DUANE ARNOLD ENERGY CENTER

AMENDMENT TO FACILITY OPERATING LICENSE

Amendment No. 49
License No. DPR-49

SAFETY EVALUATION

FIGURE 4.6-1

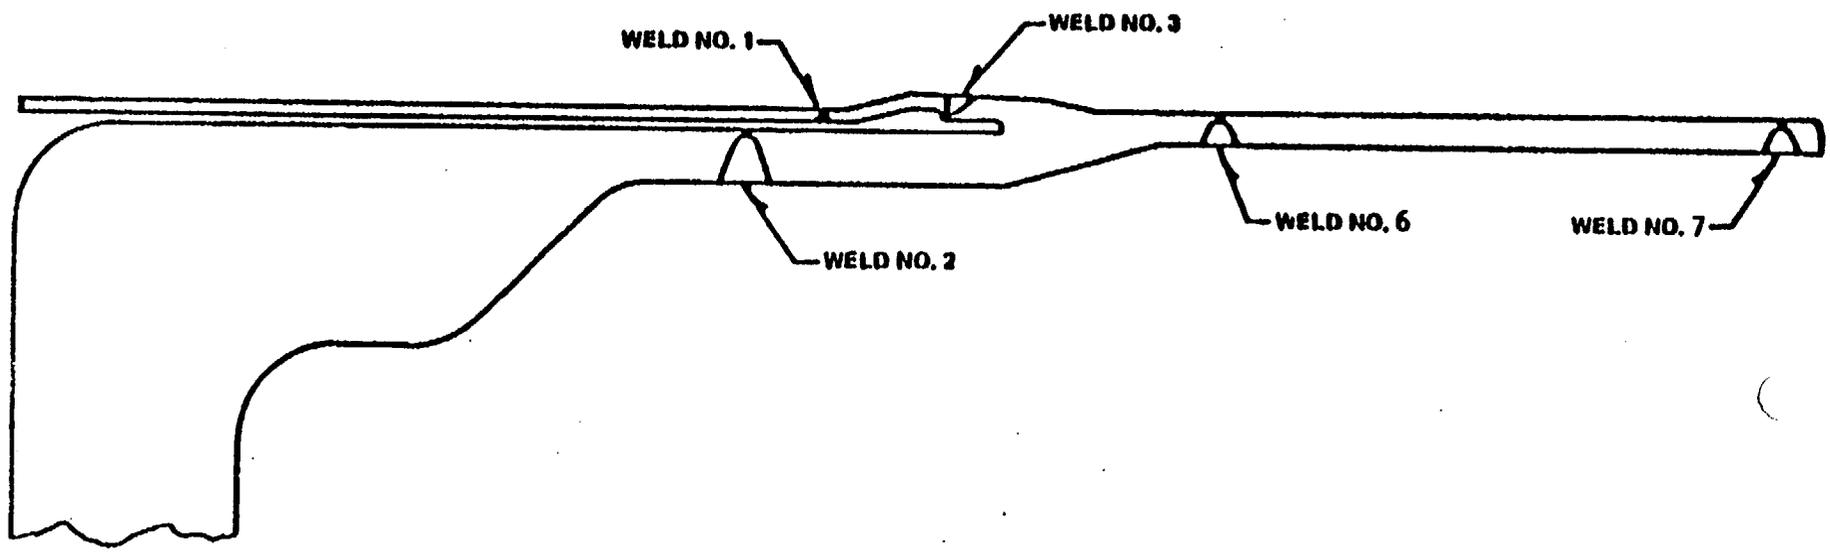
Although there were differences of opinion regarding the detailed weld root geometry and conditons as determined from interpretation of the radiographs, it was agreed that the evidence clearly showed a wide range of conditions existed from weld to weld and even from place to place on some individual welds. Therefore, the licensee characterized the root conditions at weld numbers 2 and 6

FIGURE 2: Analyzed Notch Configurations at Root of Safe End to Piping Weld (Weld #6)

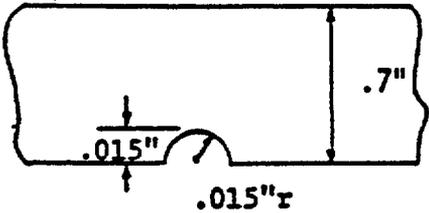
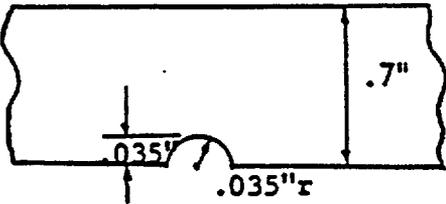
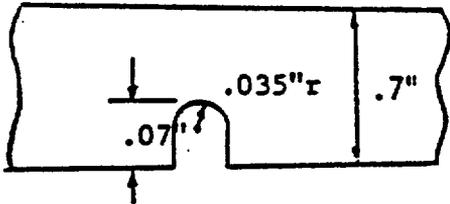
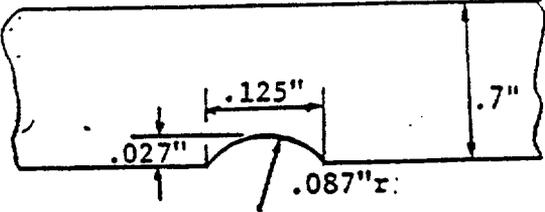
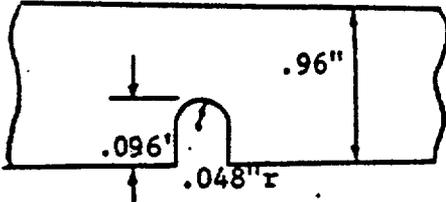
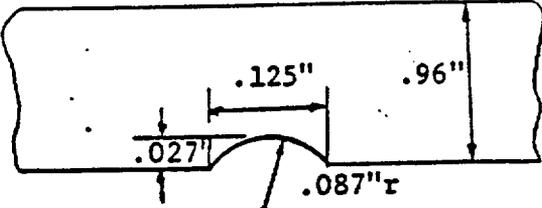
(see Figure 1) by assuming and analyzing six different notch configurations (see Figures 2 and 3). These notch configurations were chosen by the licensee to conservatively bound, relative to mechanical strength, the worst root conditions that could be inferred from the interpretation of the radiographic films. The worst-case condition enveloping all the stated variations is a sharp cup-shaped intrusion, with a depth of about 1/10 the wall thickness. This condition is designated as Case E* in the licensee's analyses. There are three possible adverse effects of this assumed worst-case root condition; adequate fatigue life, initiation of stress corrosion cracking, and initiation of brittle or unstable fracture without prior warning. These three possible effects are discussed below.

The licensee performed detailed stress analyses for weld locations 2 and 6 in accordance with the requirements of Section III of the ASME boiler and Pressure Vessel Code assuming the notch configurations shown in Figures 2 and 3. The results of the original stress analyses were modified to account for the reduced wall thickness at the assumed notches and to obtain primary stress intensities and primary plus secondary stress ranges. No credit was taken for any weld reinforcement at the outer weld surface. In addition, theoretical stress concentration factors were determined for Cases A through D and F for the calculation of the fatigue usage factors. For Case E, a fatigue strength reduction factor of 4.0 was used which is the highest value required by the ASME Boiler and Pressure Vessel Code for a partial penetration weld.

The analysis of weld numbers 2 and 6 for each of the assumed notch configurations, considering the reduced wall thickness and the fatigue reduction factors, show that the calculated stresses and fatigue usage factors are within the limits prescribed by Section III of the ASME Boiler and Pressure Vessel Code.

* The letters A through F refer to the notch configurations analyzed by the licensee as shown in Figures 2 and 3.

The staff has evaluated the fatigue analysis and agrees with the licensee's evaluation.
